Delegated Report

Householder Planning Application

Planning Application No: 20240542

Description: Erection of a two storey side extension.

Google image

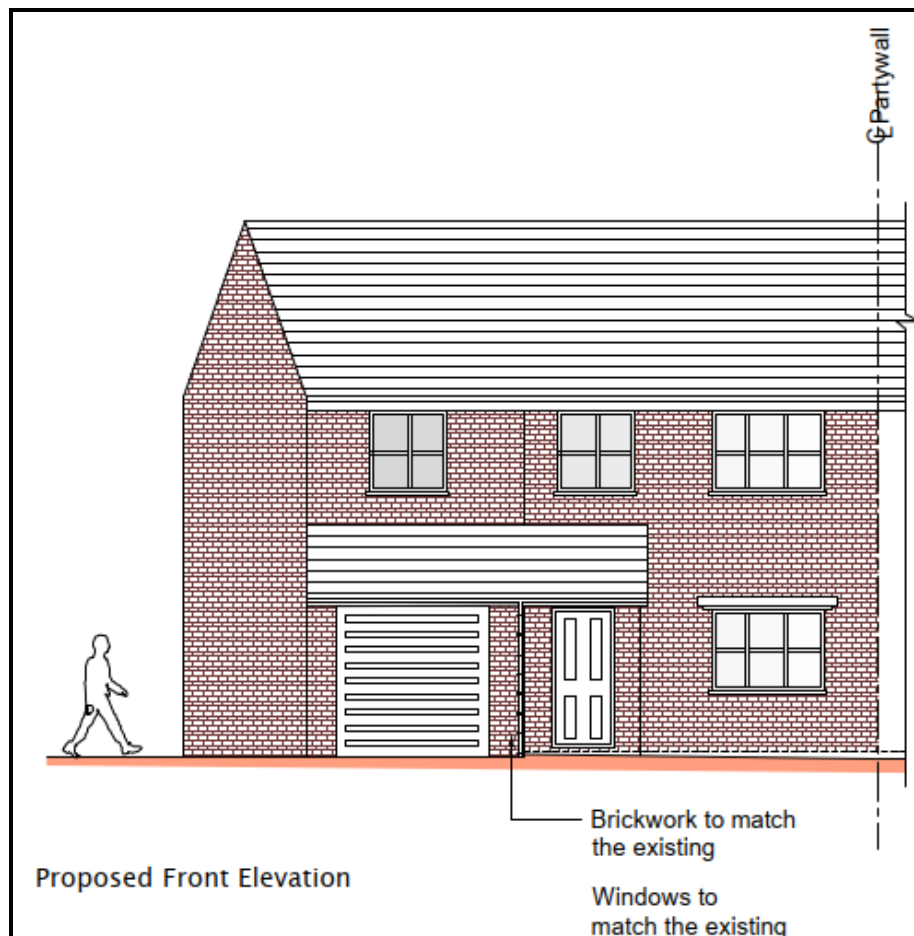
The proposed development would also meet the flank boundary contrary to the guidance. There is an existing character of wide gaps between existing pairs of semi-detached dwellinghouses and this symmetry and spaciousness between buildings would be corroded by the proposed extension. This dwellinghouse is viewed in conjunction with its attached neighbour. Currently there is symmetry between semi-detached dwellinghouses, including this pair and whilst it is not generally expected that semi-detached dwellinghouses should adhere completely to the design of neighbouring properties to retain symmetry, there should be a balance between these dwellinghouse visually. This symmetry is shown in the google earth image below:

This proposal in comparison would double the size of the dwellinghouse, in footprint and width, and would visually eradicate any symmetry with this adjoining neighbour.

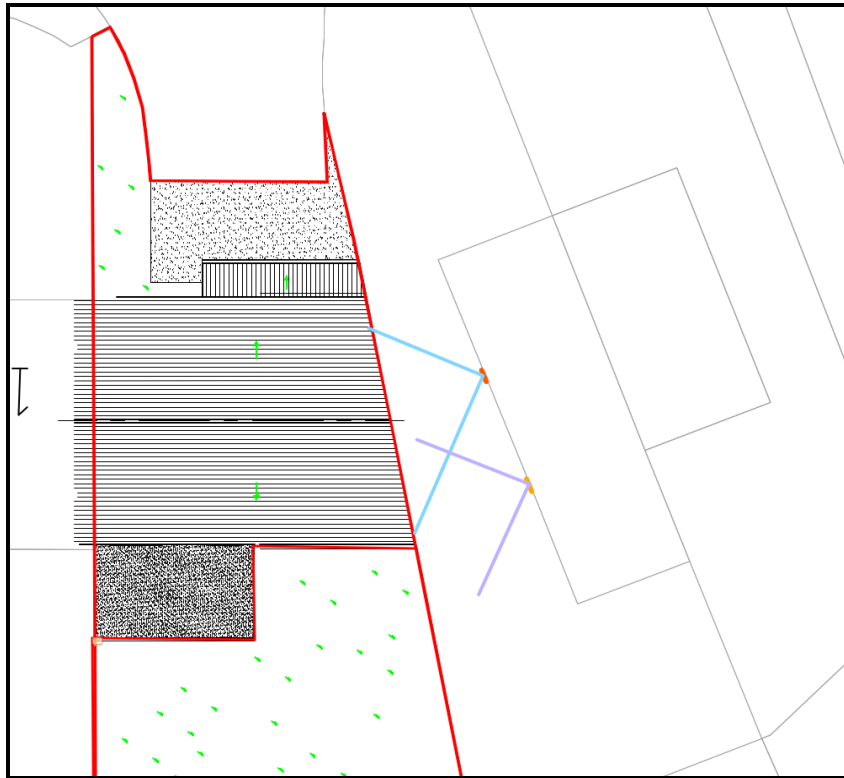
Conversely, the proposed two storey side extension would be prominent, overbearing and uncharacteristic due to its poor design and layout which fill the entire width of the plot.

character for buildings in this area. The proposed development would be significant in scale, bulk would not appropriately reflect the subservient nature of the existing roof form and would disbalance the existing symmetry with its adjoining neighbour so as to result in a significantly harmful impact to the character of the area and the streetscene.

45 degree test

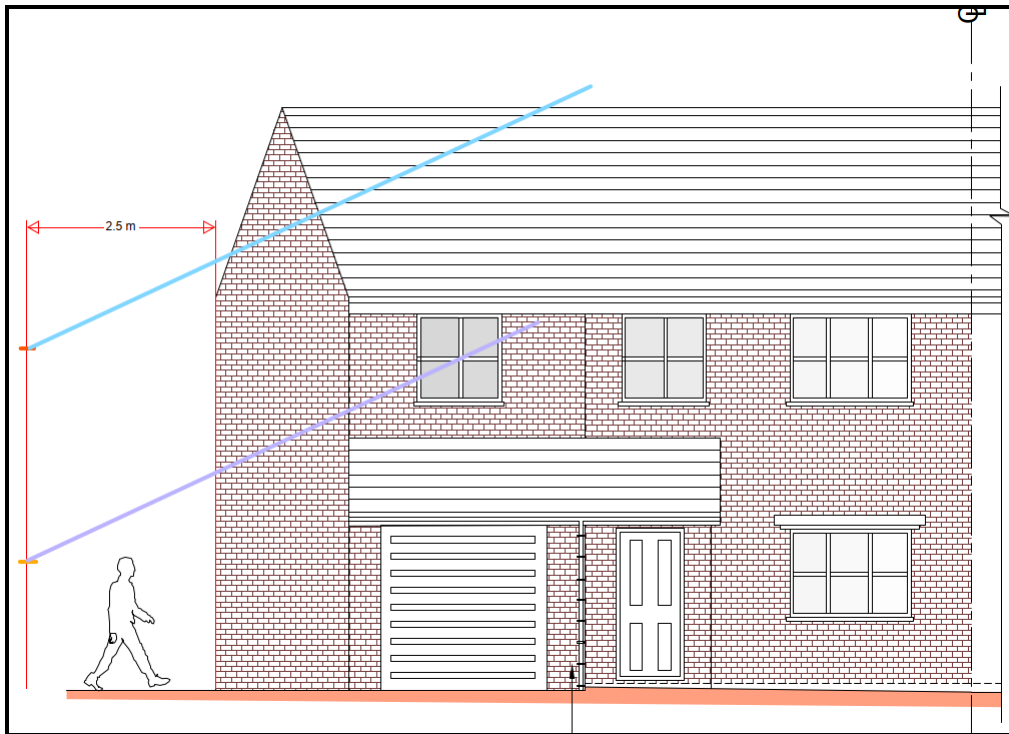
The below 45- and 25-degree tests shows the approximate positions of the windows, taking into account the slightly higher ground level of no.19. The tests show the potential of the proposed extension to overshadow these windows.

As the above tests show, there is potential for overshadowing to the bathroom and kitchen.

Figure 1

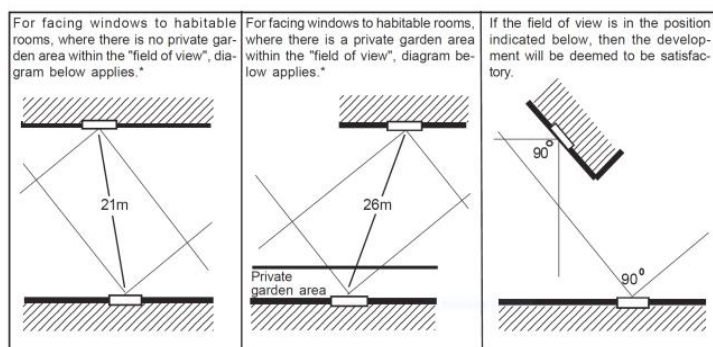
Concerns regarding overlooking have also been raised. No windows are proposed to the side elevation and so no direct overlooking would occur to neighbouring property no.19. The neighbours across the road would have additional front facing windows, facing their property. These neighbours are 21.6m from

the subject dwellinghouse and so the new windows would comply with the minimum 21m privacy distance applied by the Residential Layout Guidelines (2006) and as detailed in the figure below.
